BULLETIN: CA-SB-19-D-87-106

3200MP SOFTWARE (EPROM) CHANGES

To provide information on the changes in 3200MP control logic relative to the basic and options EPROMs and to introduce a means of identifying compatible combinations of basic and options EPROMs called versions.

For Use With: 32MP EPROM REPLACEMENT & COMPATIBILITY INSTRUCTIONS SEE BELOW  
 Date: 3/14/89 Part Description Part Number  
 Prepared By: D. RYDER Instruction Sheet Number 99TA550104  
 REV. B

Fig. 3 - Memory Expansion

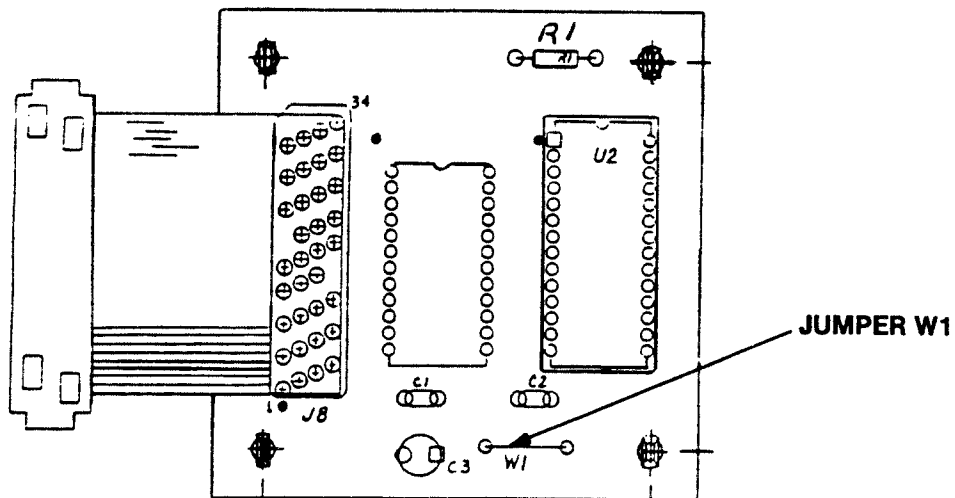
Cut jumper W1 on 32MP400874 to convert it for use with ESP I EPROMS on single compressor chillers. See attached sketch. Jumper W1 is needed for ESP II and all 19DR dual compressors.
